Commercial Components Technical Bulletin

SUBJECT: Replacement of W7459Axxx and M7415Axxx with W7220A1000 (JADE) and M7215A1008	Ref. Number	
	Issue Date	03/15/12
	Author	Adrienne Thomle and Serafima Higginson
Suggested Model Number: W7459	Date Codes Affected: N/A

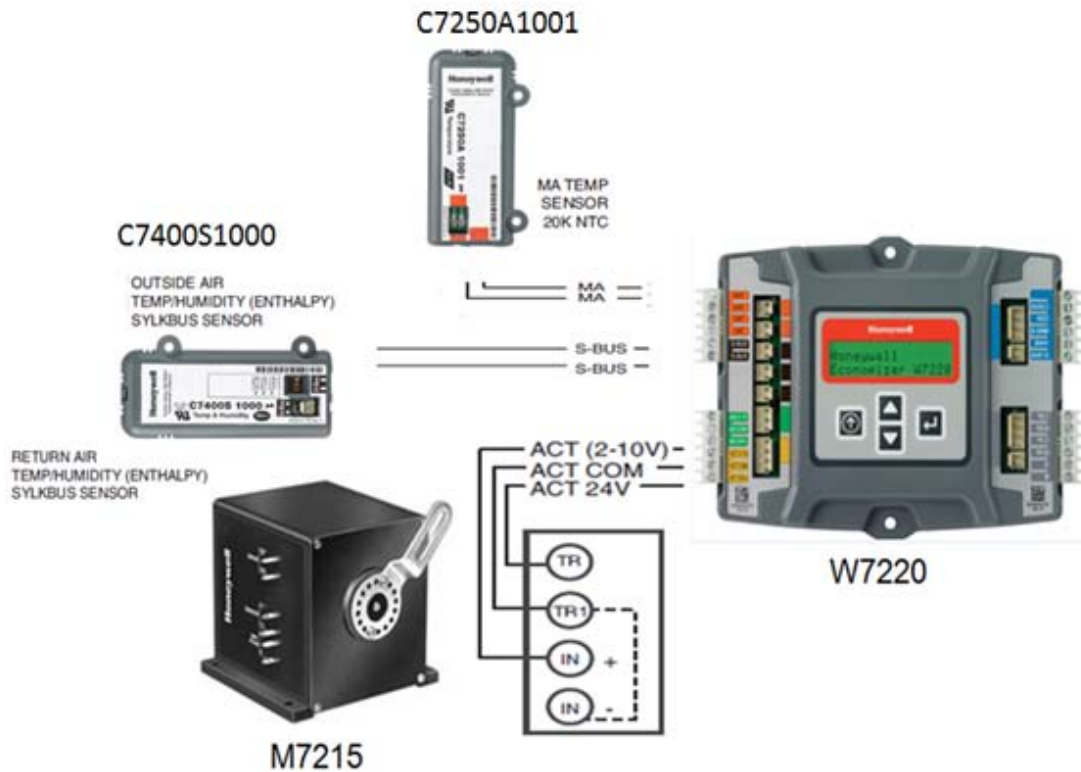
1. Remove all wires from the W7459. Mark each wire with the terminal designation (e.g., 1,2,3,4, TR1, TR etc.) as it is removed from the W7459.
2. Remove the M7415 and using the same mounting holes mount the M7215 motor in it's place.
3. Mount Jade on the inside of the Rooftop unit where it will be easy to read the display and to change the settings.
4. Wire JADE to M7215 using three new wires and ¼ in quick connects on motor end of wires:

M7215 wire termination	W7220 Wire termination
TR	ACT 24V (hot)
TR1	ACT COM
IN (+)	ACT (2-10V)
